MY3 FINAL MONITORING REPORT
Banner Branch Mitigation Project
Stokes County
Roanoke River Basin
CU 03010103

DMS Project # 100080
DMS Contract # 7610 and 7701
DMS RFP # 16-007405
USACE Action ID Number SAW-2018-01760
DWR Project # 18-1154
Calendar Year of Data Collection: 2023

RE: WLS Responses to NCDEQ DMS Review Comments for Task 9 Submittal, Draft Monitoring Year 3 Report for the Banner Branch Mitigation Project, DMS Full-Delivery Project ID #100080, Contract #s 7610 & 7701, Roanoke River Basin, Cataloging Unit 03010103, Stokes County, NC

FIGURE
1C

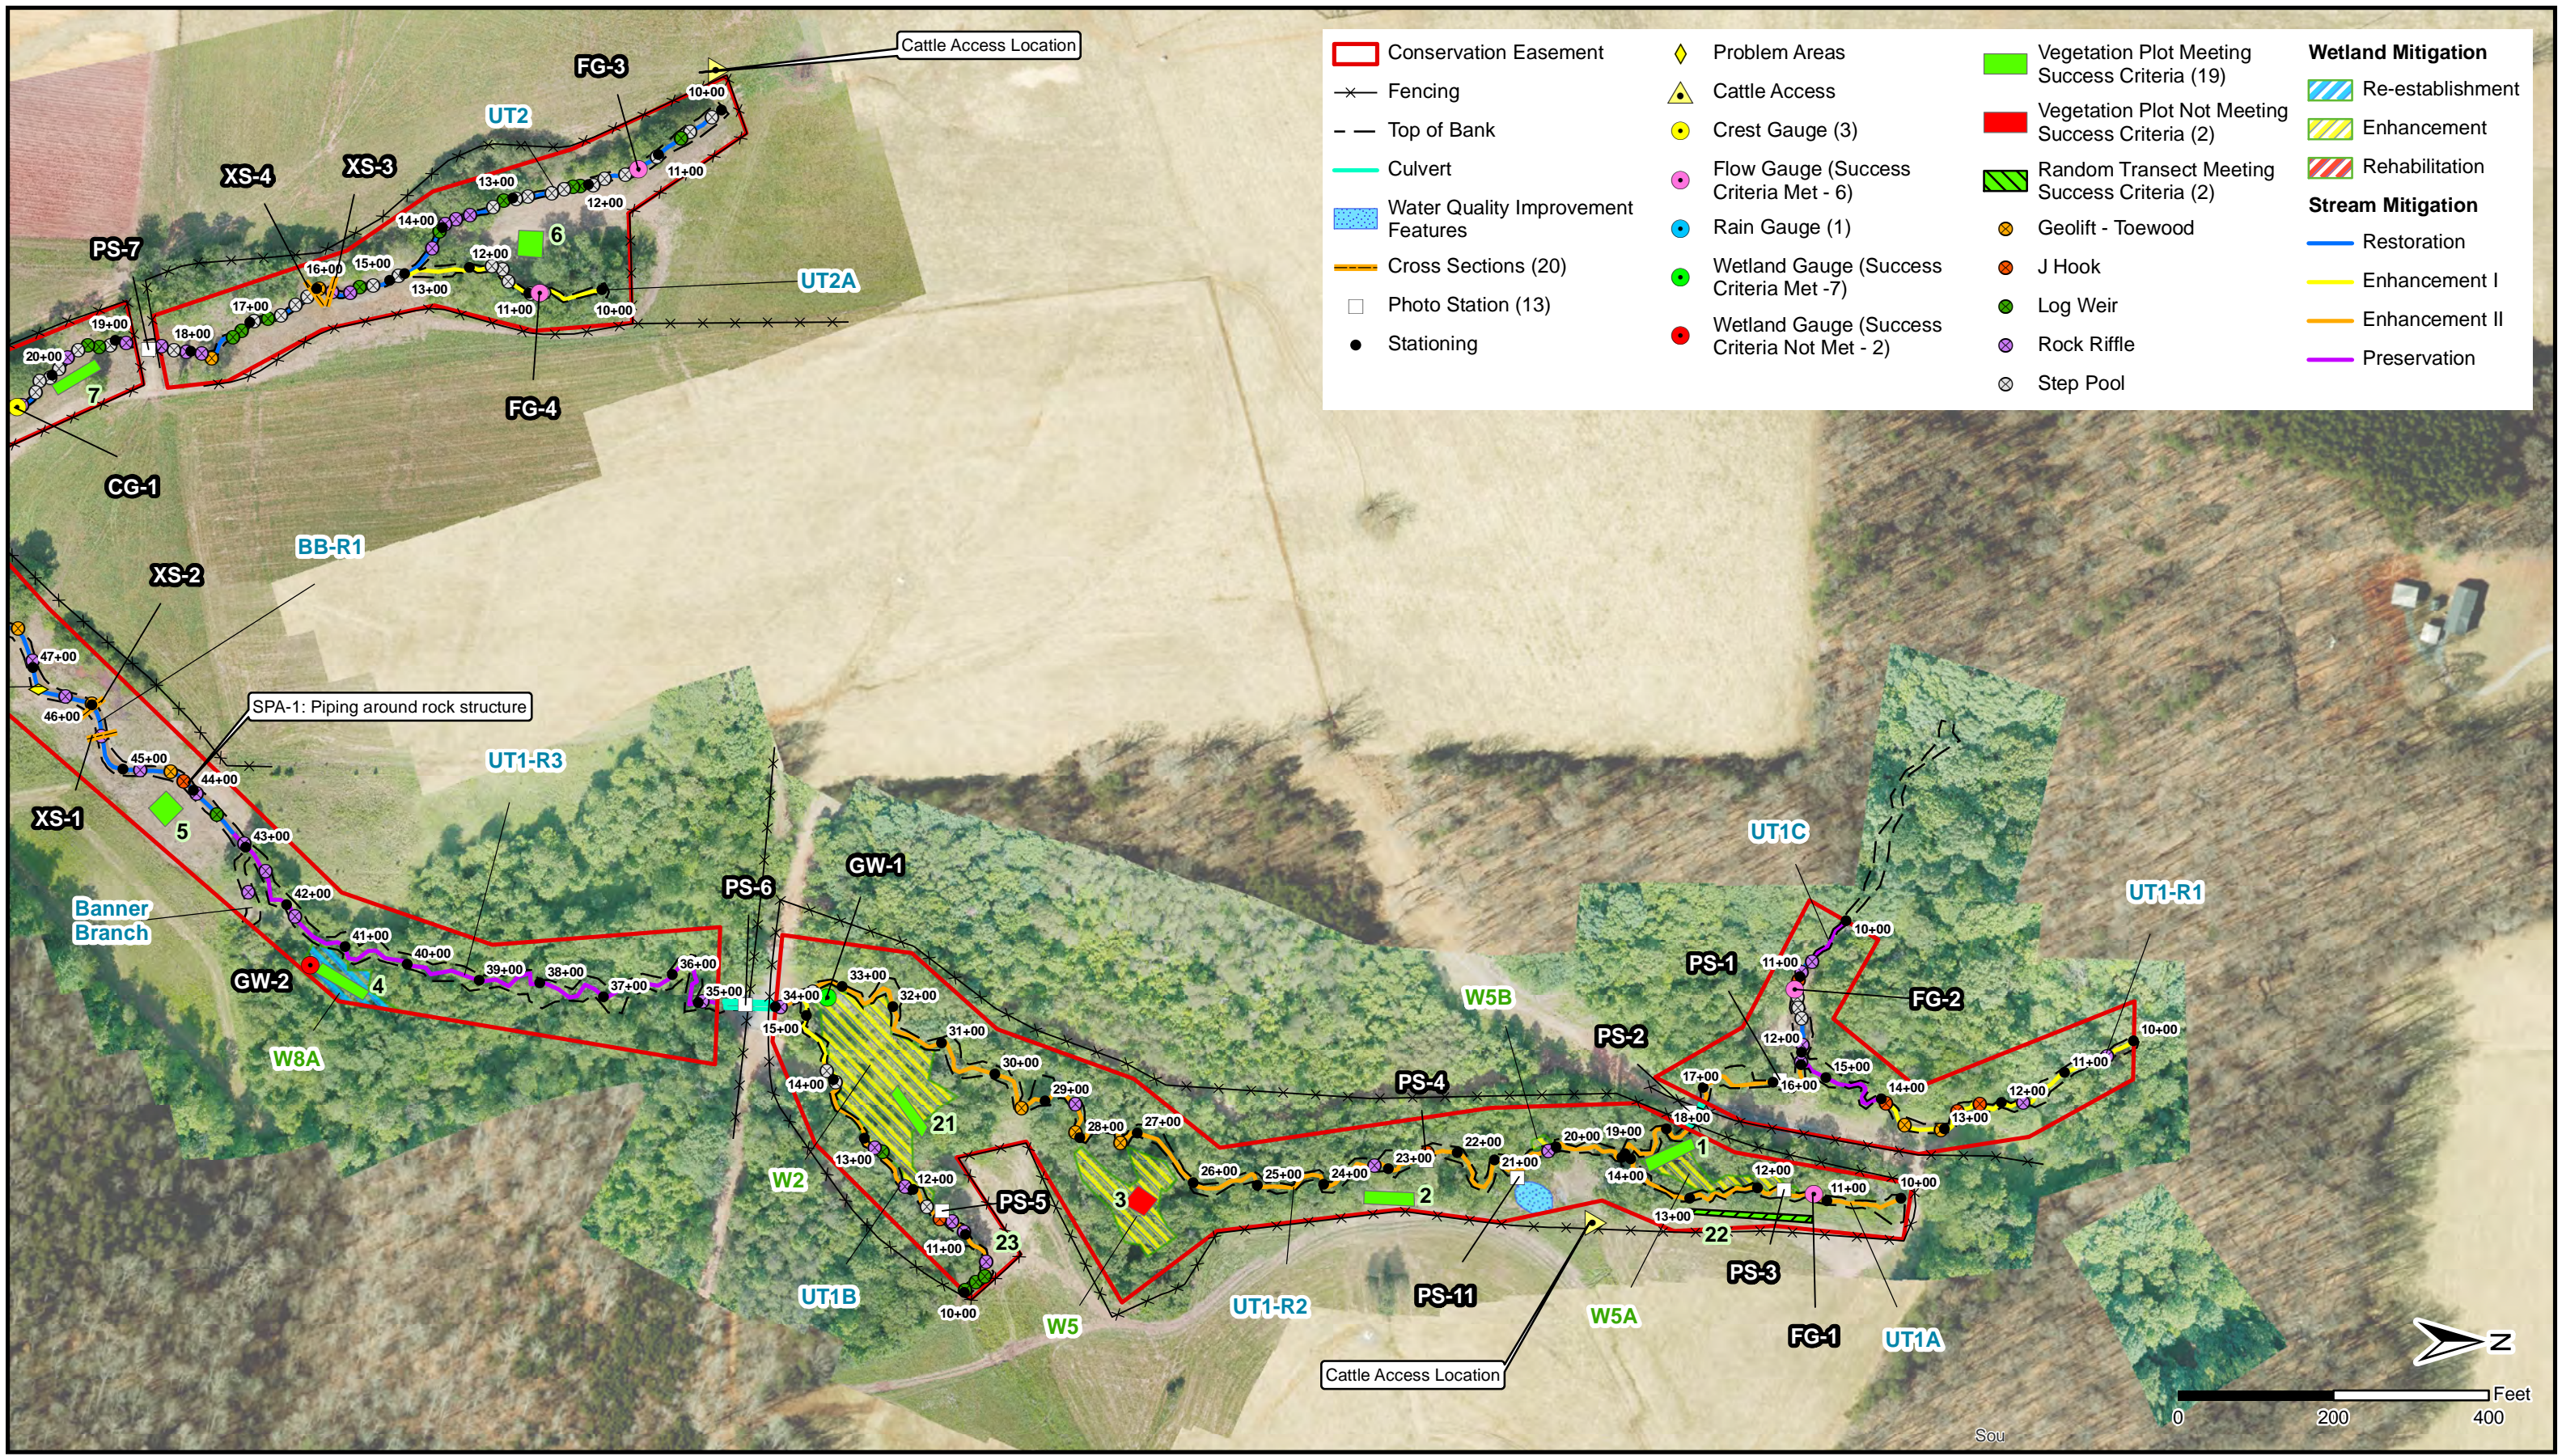
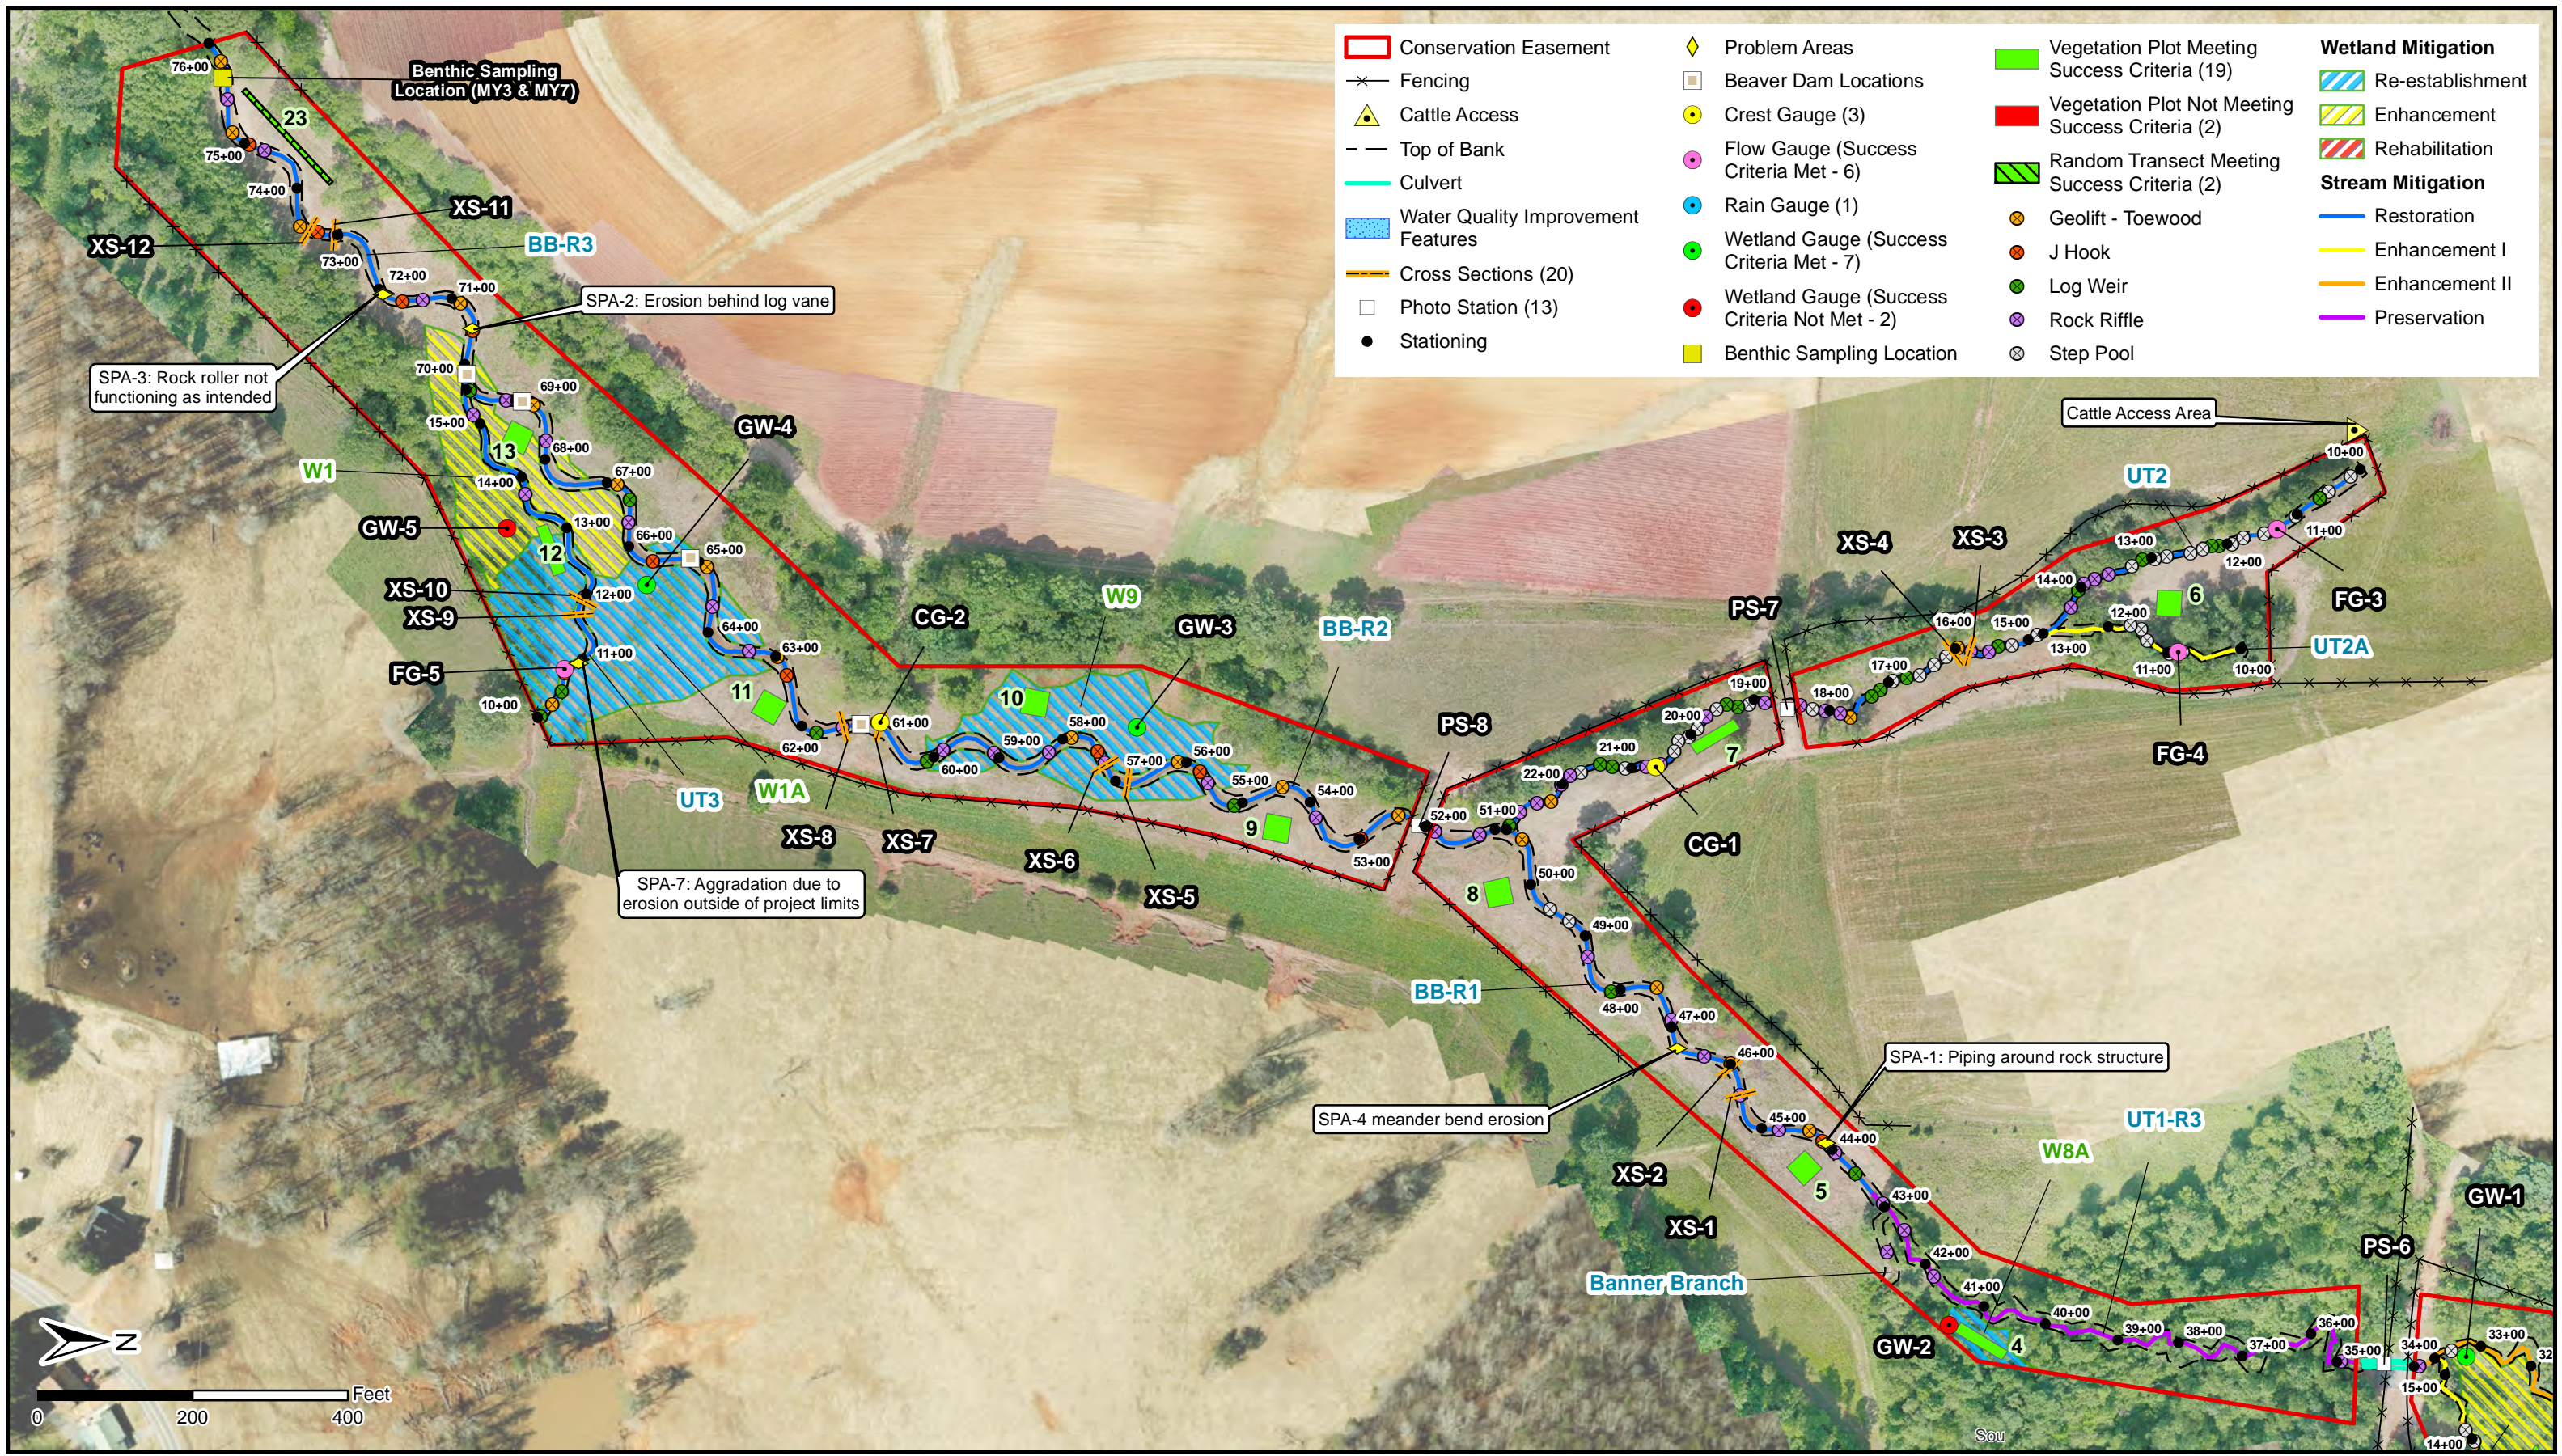
3. **On Figure 1c, recommend adding the SPA-6 label on the part of the map that overlaps with Figure 1b.** WLS Response: Figure 1c has been updated with the labelling of SPA-6.

Cross-Section 13 (UT4-R1 - Pool) MY3

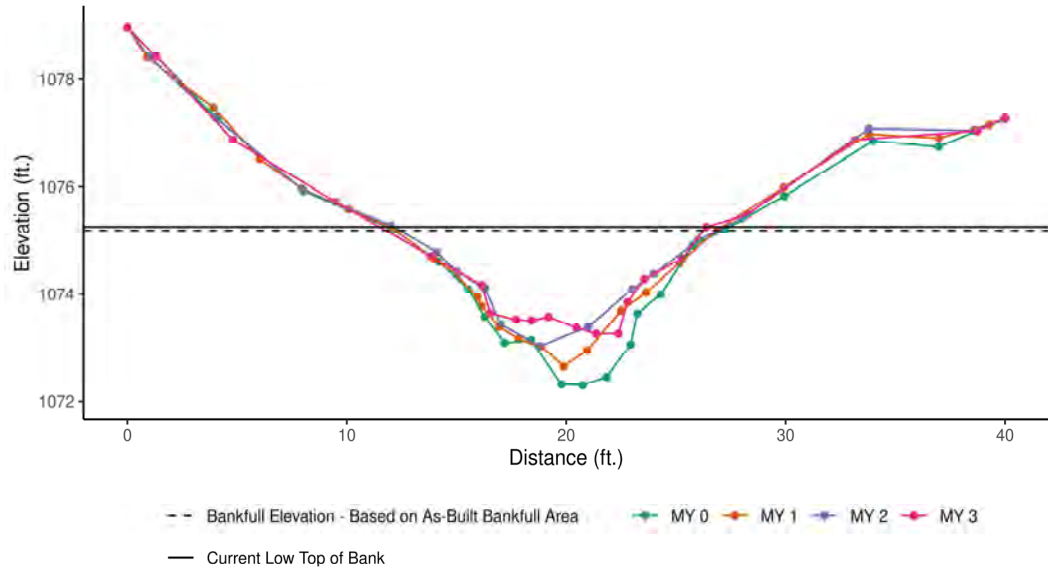
- b. **Is the LTOB cross sectional area correct on XS13? It appears that there should have been a loss in cross sectional area since MY0 based on the plotted graph. Please clarify.** WLS Response: WLS checked the input data and reexported using the DMS Cross-Section Analysis tool. The data is consistent as presented in the report and WLS is confident the data is correct.
